FIRE STATION NO.3 JSP26-18

Consideration at the request of HED | BRW Architects on behalf of City of Novi for Fire Station No.3 JSP26-18 for Preliminary Plan and Stormwater Management Plan review and approval of the location, character, and extent of the proposed improvements. The subject property is zoned I-1 Light Industrial and is located north of Nine Mile Road and east of Venture Drive (Section 26). The City proposes to develop a new fire station on the currently vacant 3.65-acre parcel.

PLAN REVIEW CENTER REPORT

Project Name: JSP26-0018 Fire Station No.3 (22700 Venture Dr)
Review Date: June 10, 2026
Review Type: Preliminary Site Plan
Plan Date: May 15, 2026
Prepared By: Lindsay Bell, AICP, lbell@cityofnovi.org (248) 347-0587

1 ARCHITECTURAL SITE PLAN

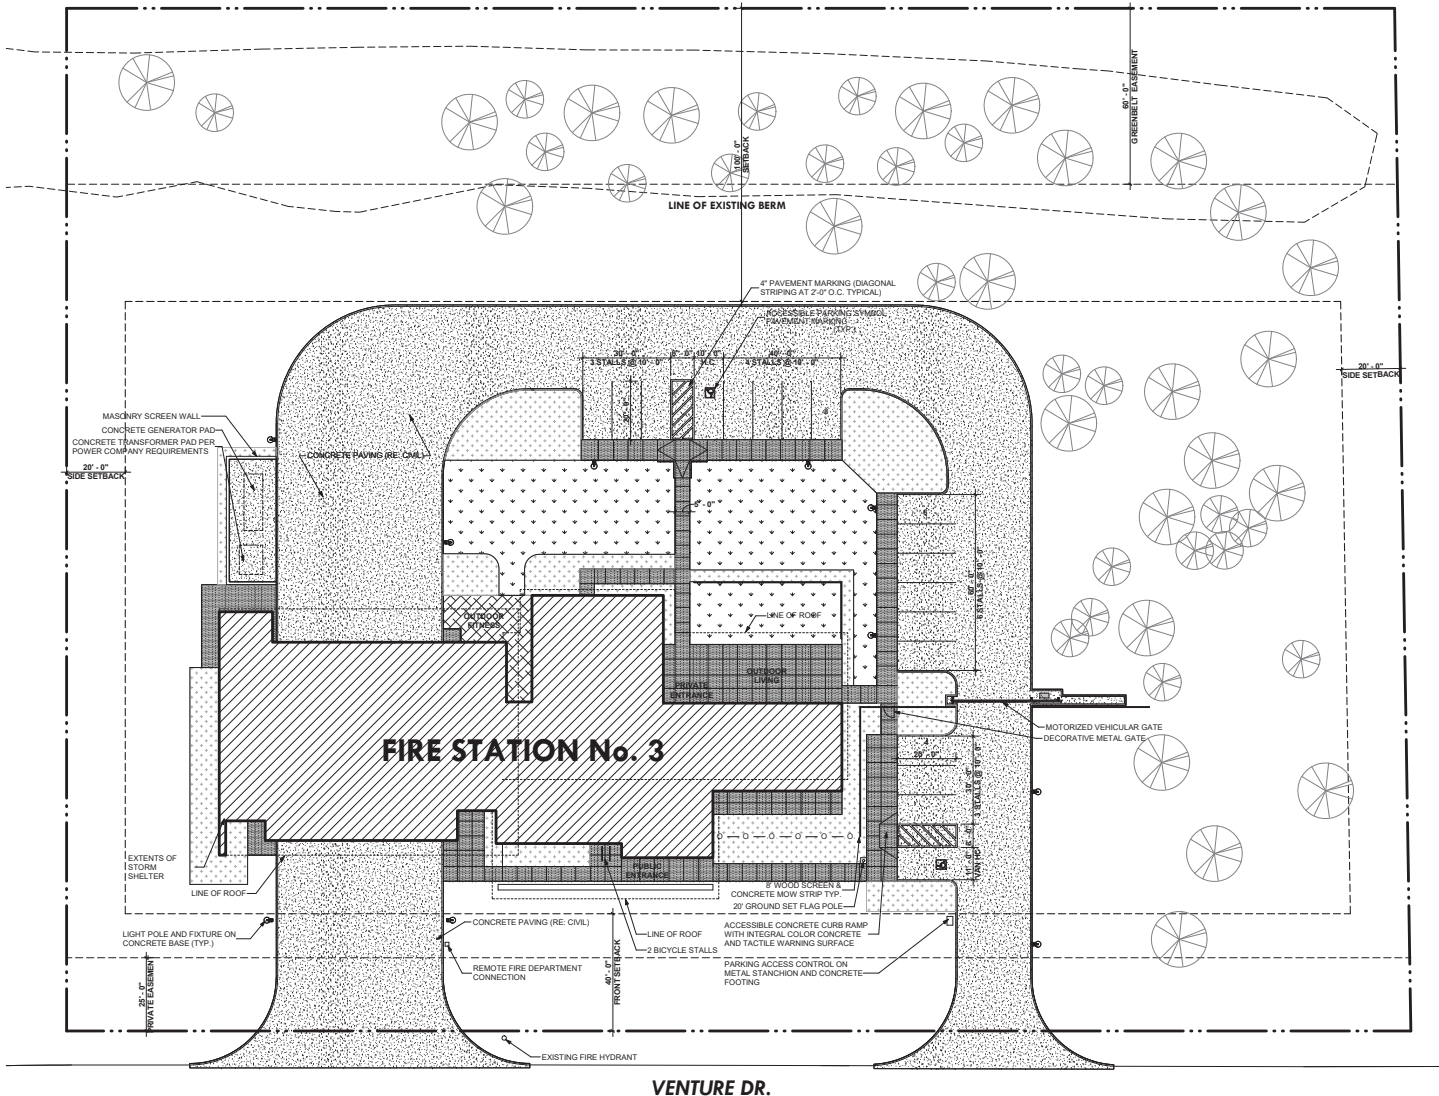
4. Items that do not conform to the Ordinance requirements: The following items do not conform to the standard Ordinance requirements:
 - a. Building height exceeds 25-foot limit where adjacent to a residential district (31-32 feet proposed). The applicant's response letter states the additional height is required to accommodate apparatus maintenance clearance and training within the apparatus bay.

- c. Existing berm adjacent to the residential district is deficient in height (~4-6 feet existing, minimum of 10 feet required).
 - d. The Landscape Plan is deficient by two accessway perimeter trees. As stated in the review letter the applicant is encouraged to correct this in the next submittal.

Building Setbacks (Section 3.1.18.D) (Sec. 3.14.5.B)	Front: 40 ft minimum	65 ft	Yes	See Note to District Standards, Sec 3.6.2.B for non-residential uses in residential district
	N Side: 20 ft minimum	52 ft	Yes	
	S Side: 20 ft	192.5 ft	Yes	
	Rear adj to res: 100 feet (Sec. 3.14.5.B)	200.2 ft	Yes	
Building Height (Section 3.1.18.D) (Sec. 3.14.5.C)	Maximum 40 feet except where adjacent to Residential: 25 ft	31-32 feet	No	Building height listed as 31 ft and 32 ft – please clarify

Grading Plan

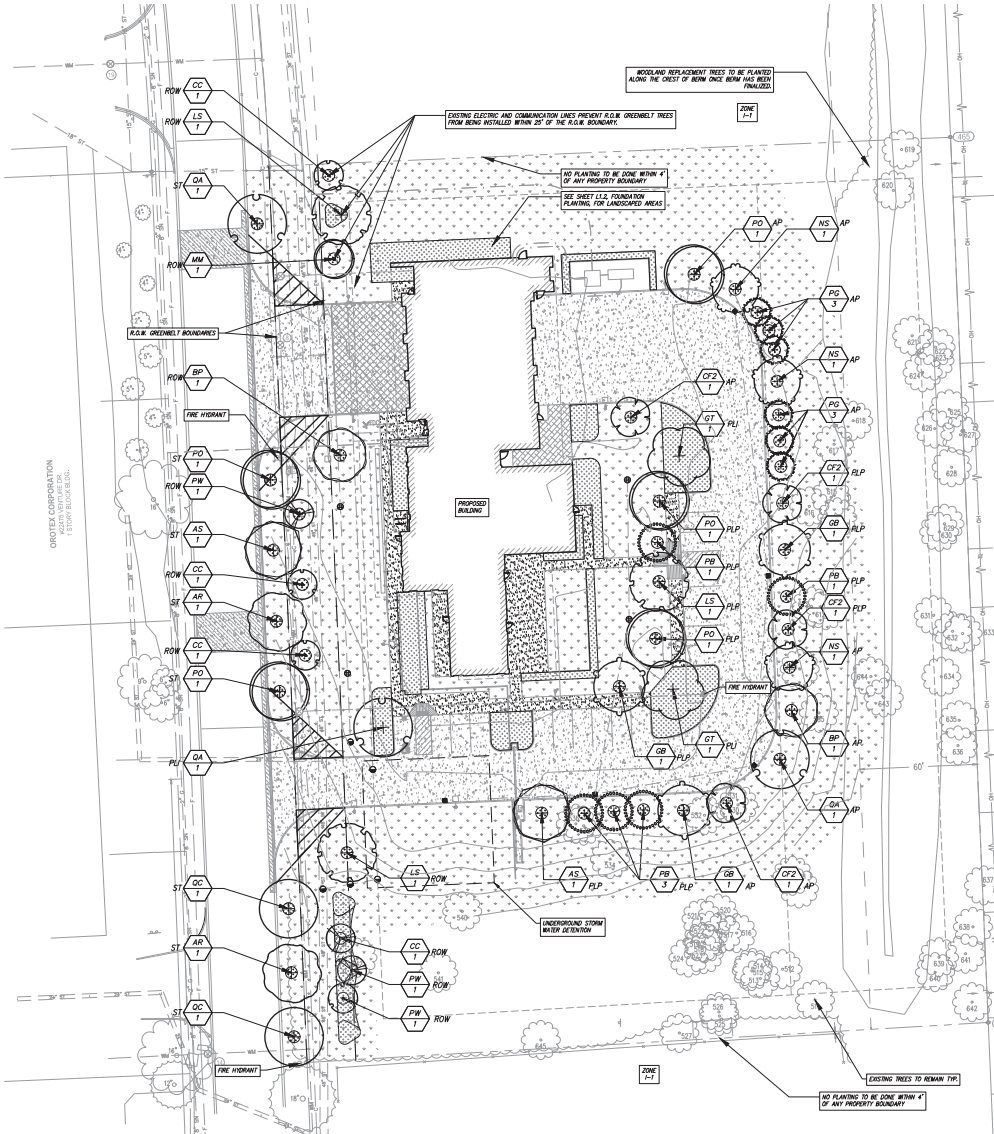
3. Proposed grading. 2' contour minimum - Please add spot elevations along the east edge of the access drive to verify how high the berm is in comparison to the development.
SDA Response: Contours are shown in all plan drawings at 1' intervals. Additional spot elevations will be added in future FSP
